Epoch Garments Ltd (Extension)

10 December 2023

1. Executive Summary

Observation-1: Mismatch in as-built drawing. (Admin Building)

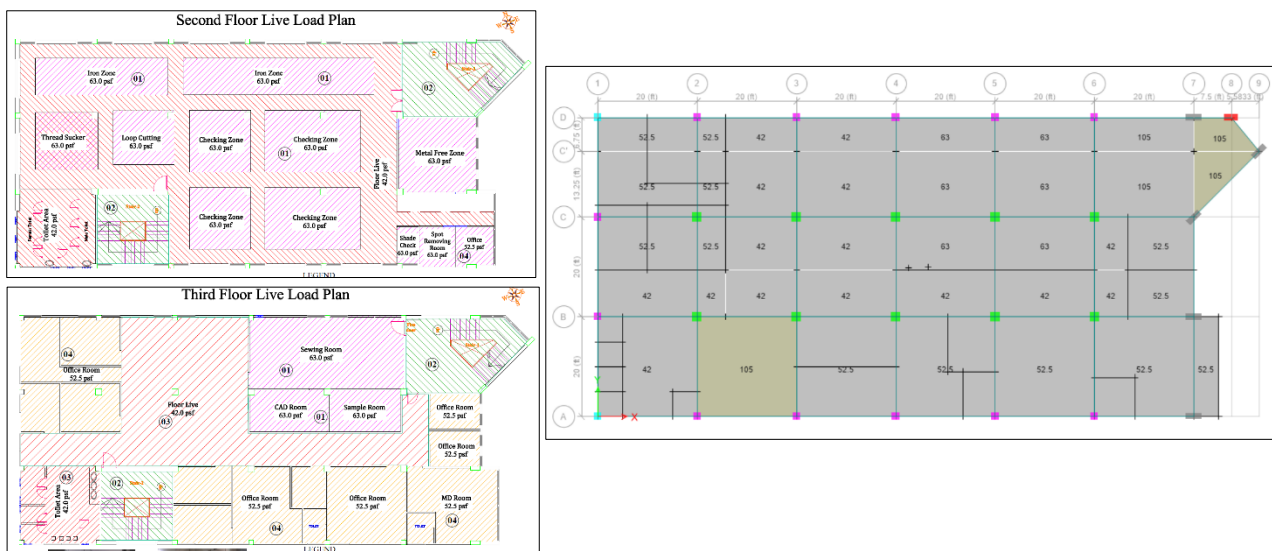
Description: Mismatch was found between the as-built drawing and the actual site condition. During the inspection, bracing size was found 2L-50X50X4mm but in the as-built drawing, the bracing size was shown as 2L-63X63X5mm. The building engineer is required to survey the whole structure and update the as-built drawing as per the actual site condition.
